# RANDAL PARK PHASES 2-5 PLAT

## SUMMARY

<p><b>Owner/Applicant</b>                  Richard Stevens                  Mattamy (Jacksonville)                  Partnership</p> <p><b>Project Planner</b>                  Colandra Jones</p>	<p><b>Property Location:</b> The subject property is located north of Dowden Road, west of Central Florida Greenway (SR 417), south of the Beachline Expressway (SR 528), and east of Narcoossee Road (±461.5 acres, District 1).</p> <p><b>Applicant's Request:</b>                  Request for Major Subdivision Plat to create the preliminary plat for Randal Park Phases 2-5.</p> <p><b>Staff's Recommendation:</b>                  Approval of the request, subject to the conditions in this report.</p>	
<p><b>Updated:</b> March 28, 2013</p>

# PRELIMINARY PLAT

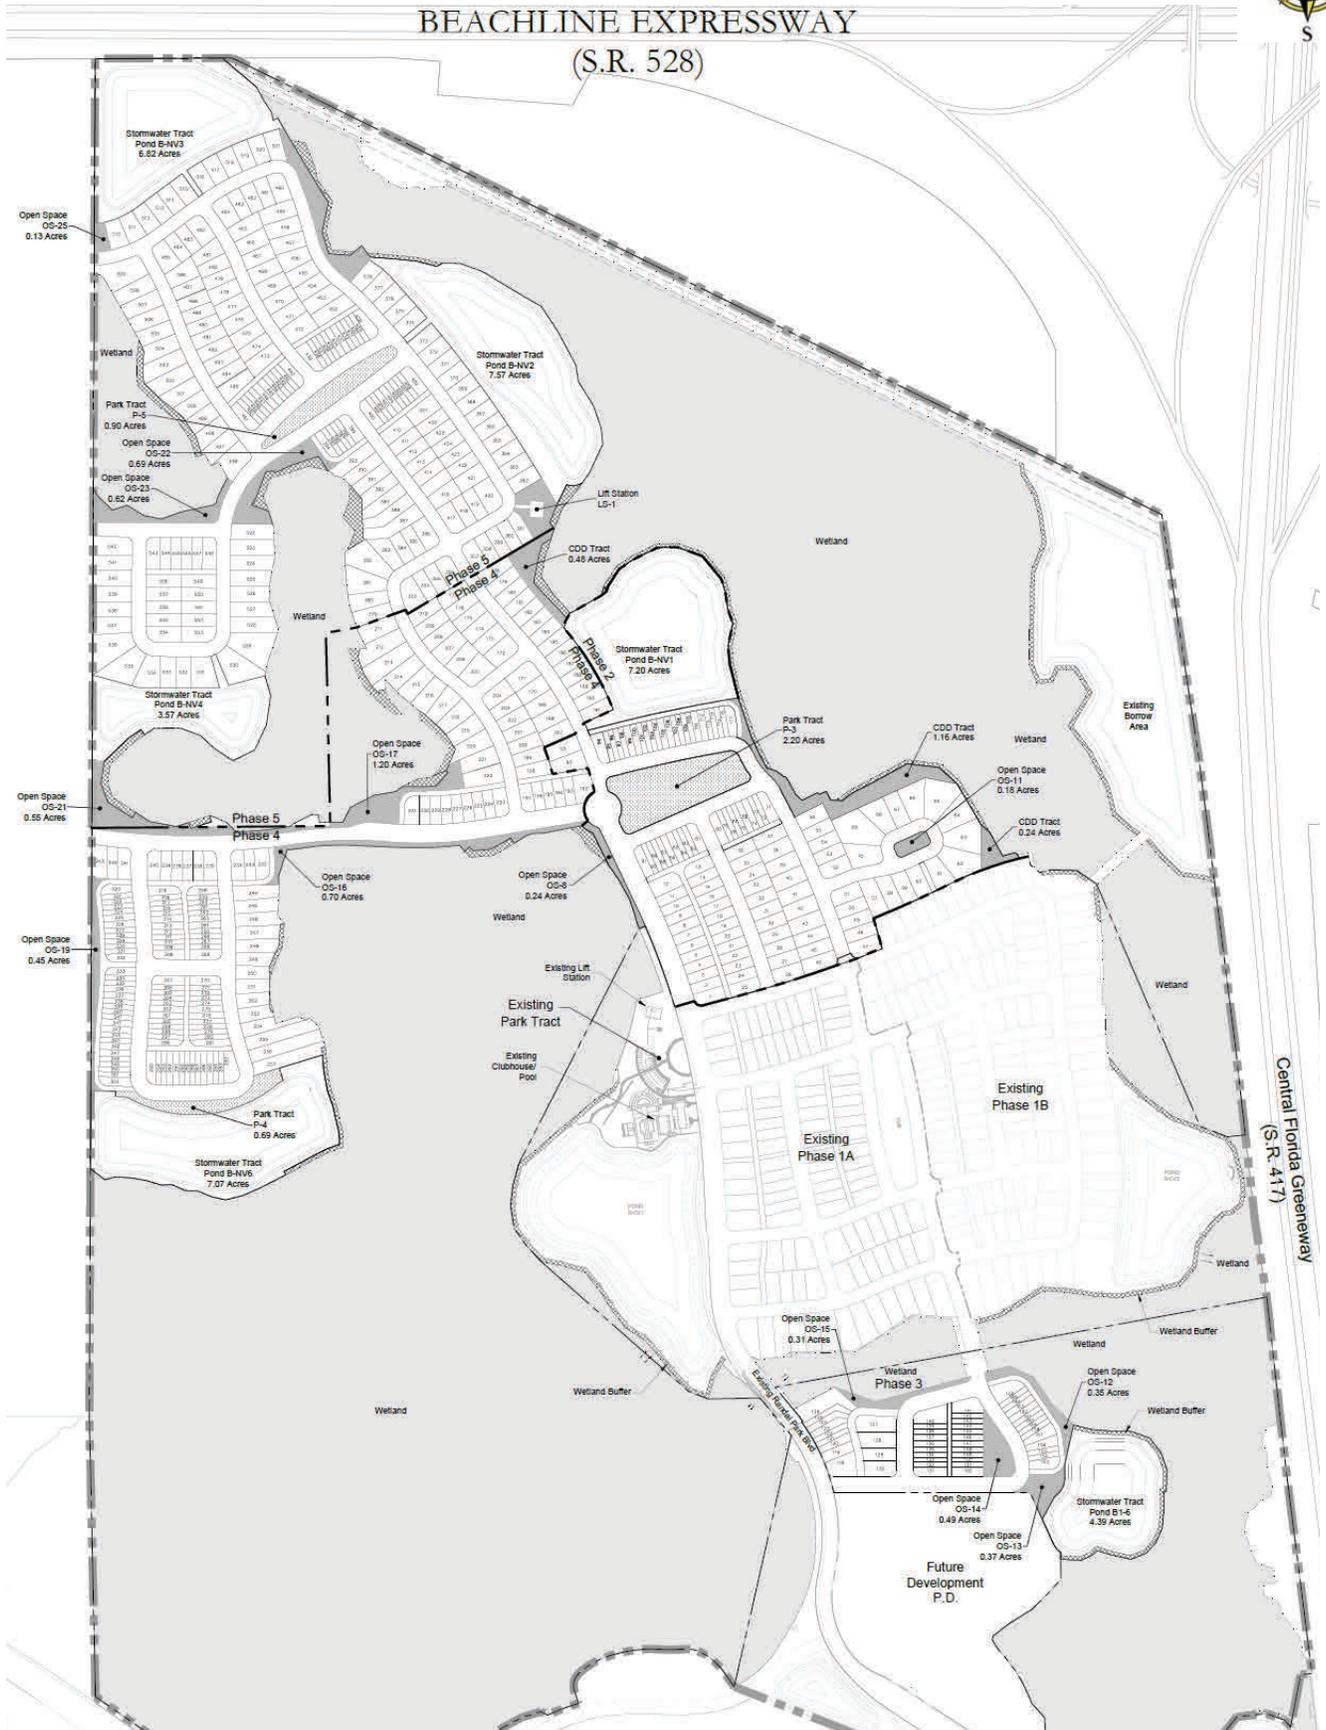
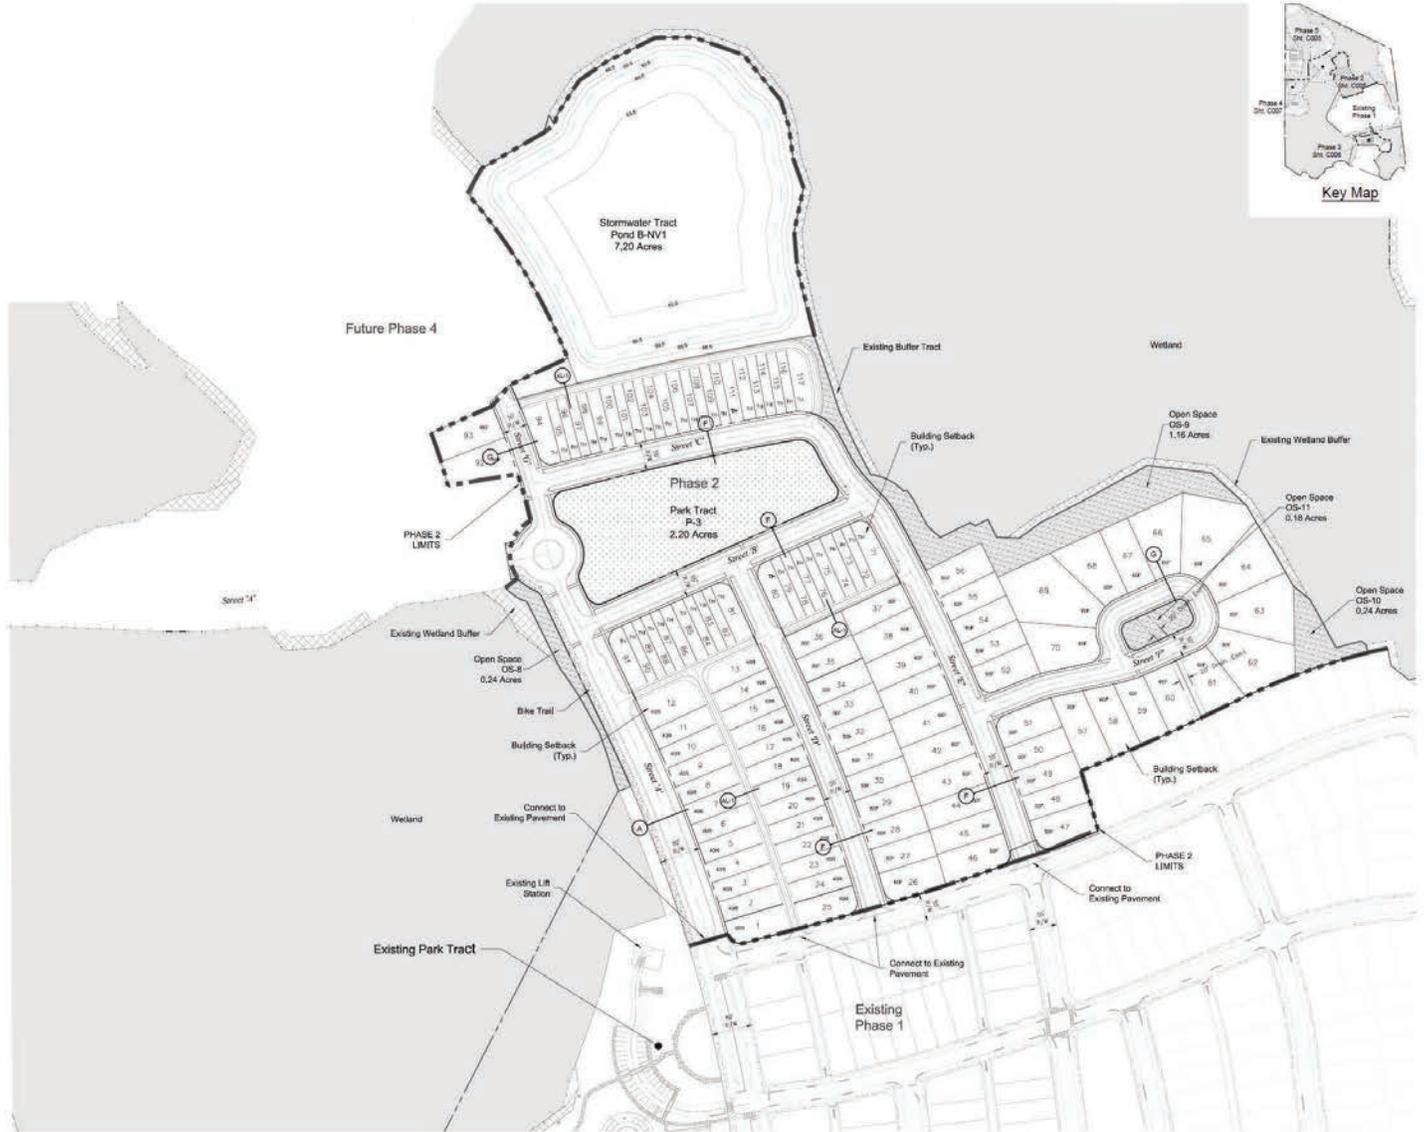
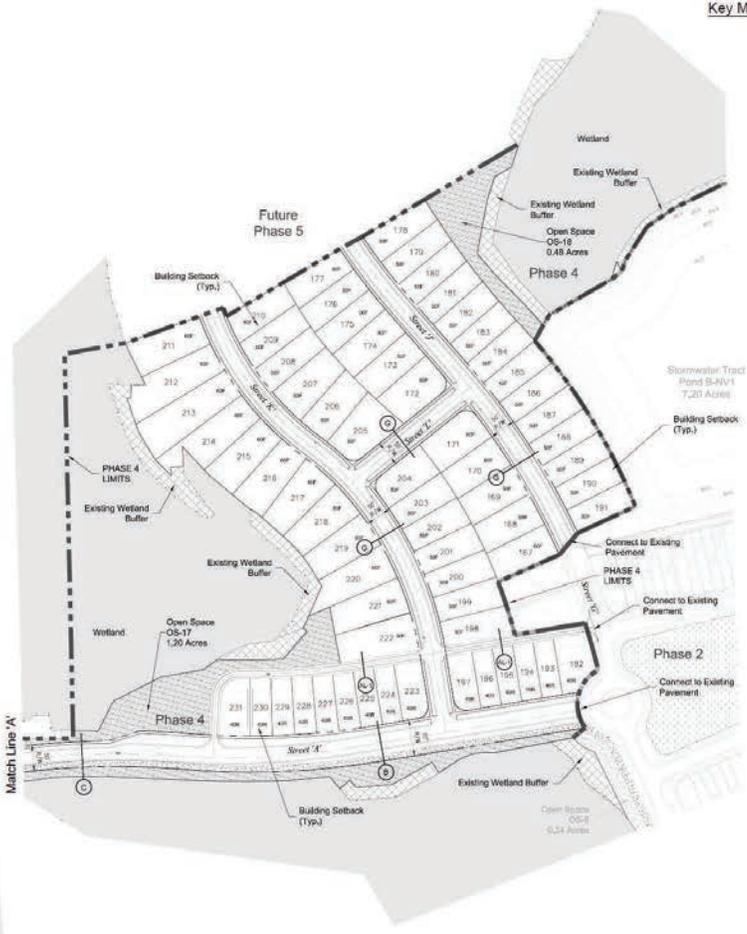
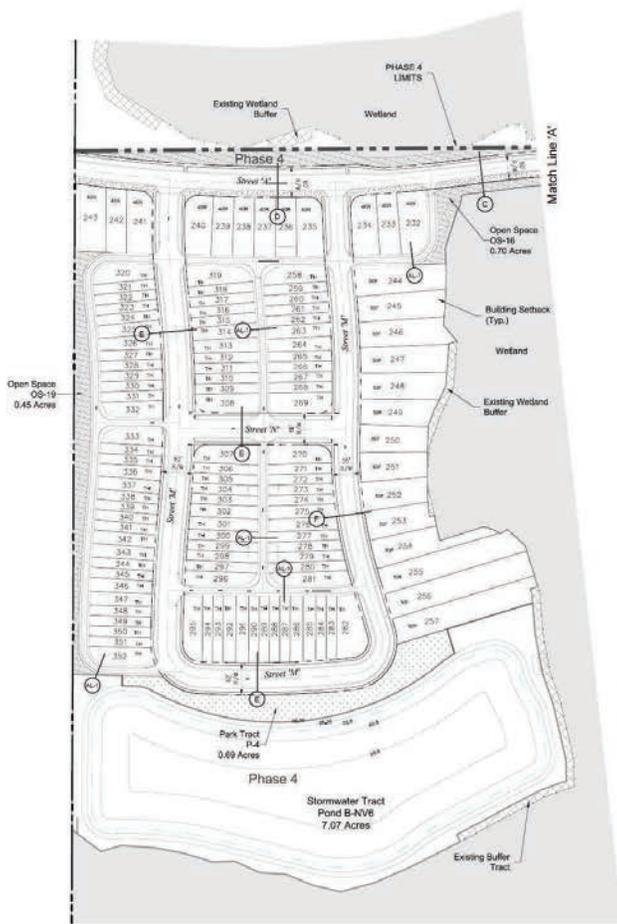
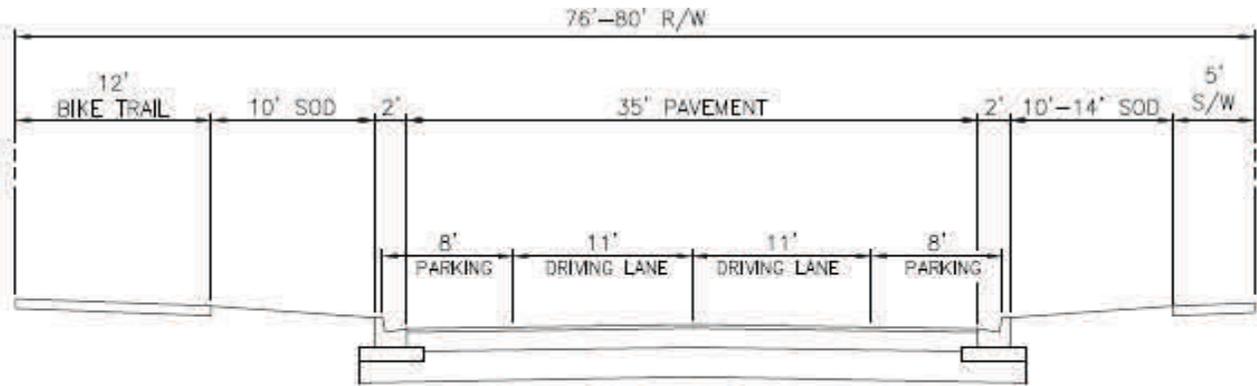
To avoid possible traffic flow problems streets Q and S need to be one way.

The following summarize the Wastewater Division comments relating to a revised roadway network and lot layout for Phases 2-5 of the Randal Park residential development:

- The gravity sewer layout to the sanitary sewer lift stations (LS-1 and LS-2) shall result in the same distribution of sanitary sewer flow as depicted on the Master Wastewater Plan and sanitary sewer calculations prepared by VHB for the Master plan dated Oct 2012.

- The connection to future development to the west shall not connect to the gravity sanitary and lift station system of Randal Park unless calculations are prepared that demonstrate the Randal Park gravity sanitary and lift station system have the capacity to serve additional flow from future development.

- The roadway and sewer in the southern most phase (shown as Phase 3), is under construction. Sanitary sewer main stubouts to serve Phase 3 have been installed as part of the sewer main construction to serve the school. Individual laterals will not be allowed to be cut in to the newly constructed sewer. Sanitary sewer service to Phase 3 shall be coordinated with the infrastructure currently under construction known as Randal Park Phase 3, case no. ENG2012-00937.

- Sanitary sewer depth shall not exceed 15' unless approved by the Wastewater Division.

# TYPICAL ROAD CROSS SECTIONS

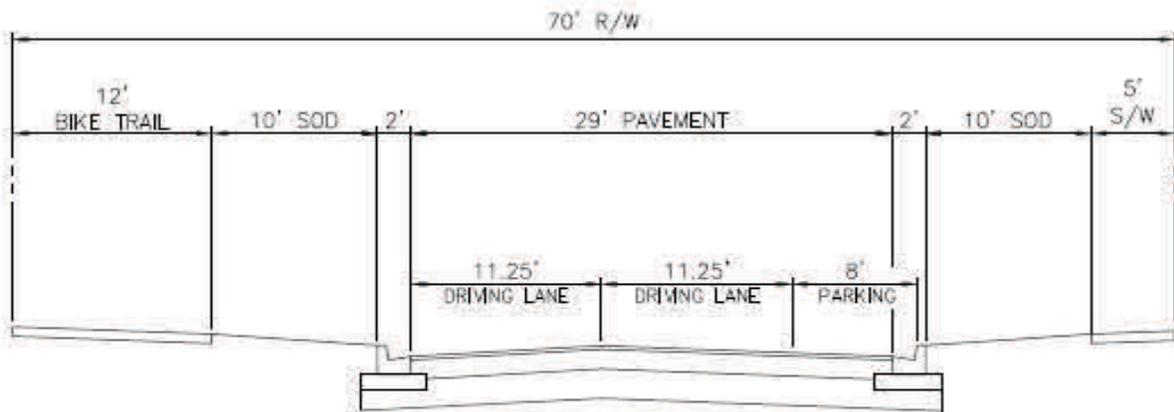
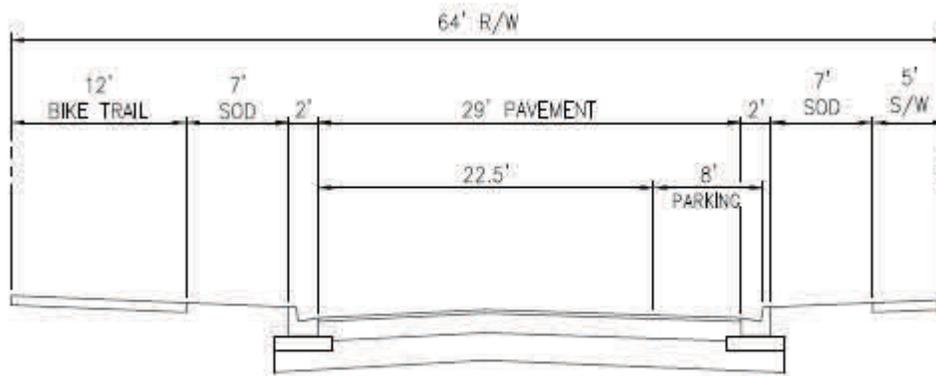
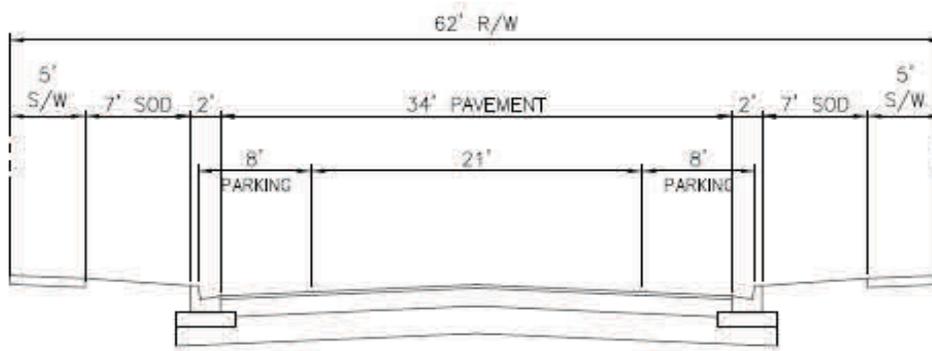
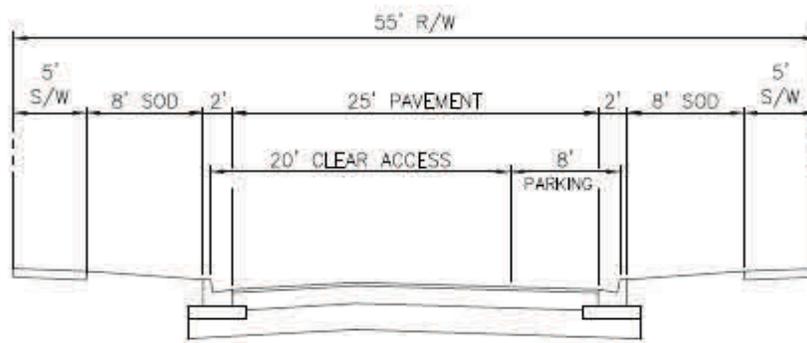
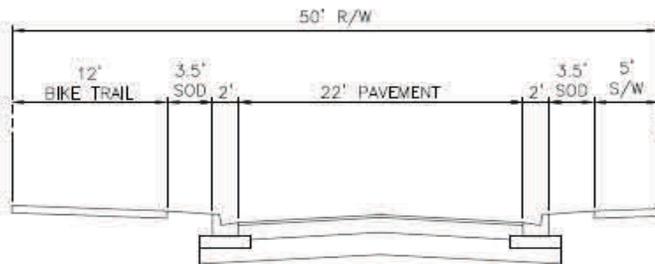
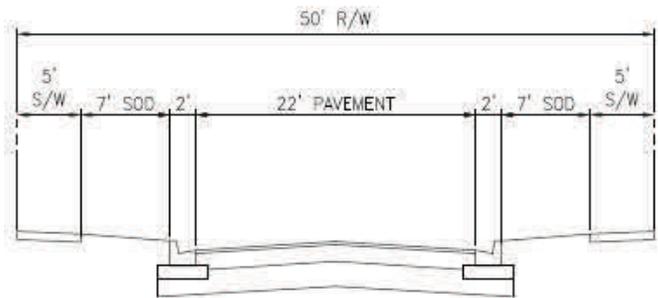
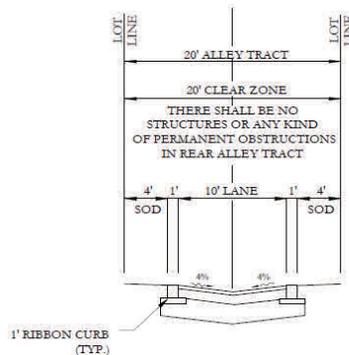
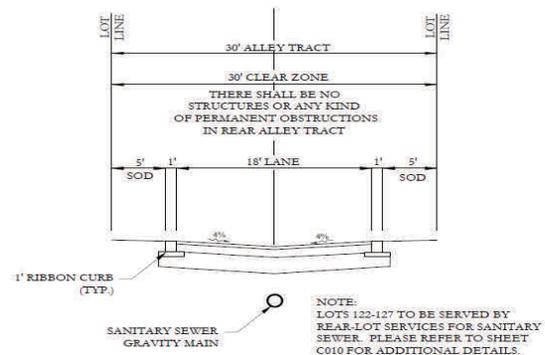
**Transportation.** According to the Randal Park PD, Section 3 provides guidelines for transportation needs. The applicant has submitted typical road cross-sections for its Neighborhood Streets and Alleys. The roadway cross-sections, which are found on page 12 and 13 of this report, shows a variety of sections which meet or exceed the PD requirements of 7 foot wide parkways, 5 foot sidewalks, 8 foot wide on-street parking spaces, and 20 foot dedicated two-way alley tracts. There are two different alley types of cross sections. There is a one-way alley cross-section which has a 20 foot right-of-way a 10 foot travel lane and 4 foot landscaping buffers. The other one-way alley cross-section has a 30 foot right-of-way with an 18 foot travel lane and 5 foot landscaping buffers.
